Response to MDE SWP Comments Related to:

“Area 1, Phase 2 Detailed Development Plan, Parcel 3 Development, Honeywell Baltimore Works Site, Baltimore, Maryland” Resubmitted November 19, 2021 and associated documents (the “DDP”),

BULKHEAD TYPE G
PLAN AND SECTION

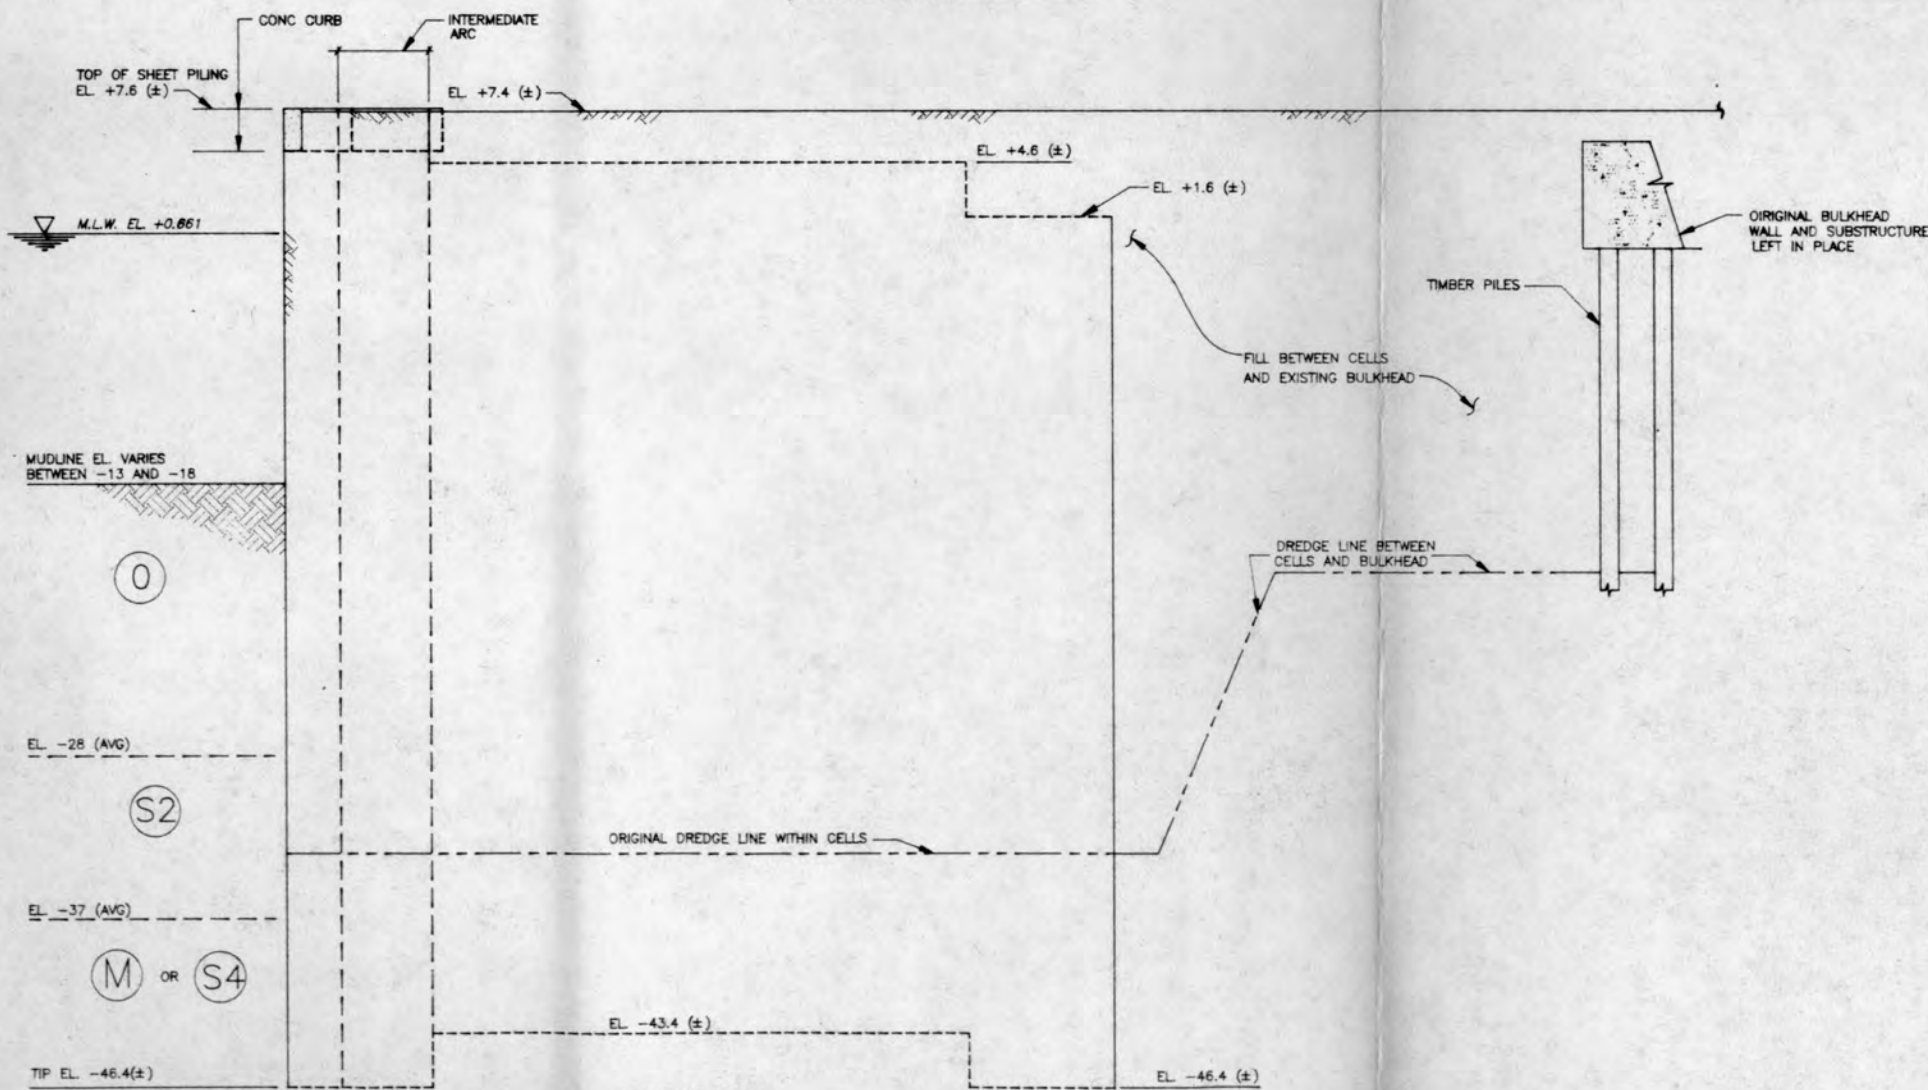
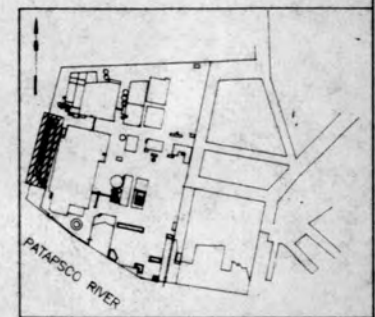
B.	<p><u>From the Response Document:</u> 1. Response II.D, regarding the Narrative Page 10, Section 3.4.2.1: MDE's previous comment referenced a description in the Narrative of 45.8' cellular cofferdams backfilled with sand and gravel, connected by steel sheet pile arcs, and requested a description of the materials used to construct the cofferdams themselves if this is known. The response was that "Strength, size, pile top elevation, and pile tip elevation are all unknown." How was it known that there are cofferdams connected by sheet pile arcs? From the response it sounds like it is known that they are pilings of some type (e.g., "pile top construction", "pile tip elevation" etc.); are they also sheet piles, and it is just the specifications that are unknown? The question is pertinent, as the performance of wooden pilings which may decay faster than steel sheet pilings may affect the performance of the cap under load.</p>	<p>Steel sheet pile coffer dams were exposed and visually inspected by Mueser Rutledge Consulting Engineers via diver and surface observation in 1989 and photographed as part of the Condition Survey of Waterfront Structures report prepared by MRCE dated May 4, 1990. Design specifications and as-built conditions upon installation were not available in the records from Allied Signal reviewed prior to embankment construction and dismantlement in the 1990s. See attached for excerpt from Condition Survey pertinent to coffer dams.</p>
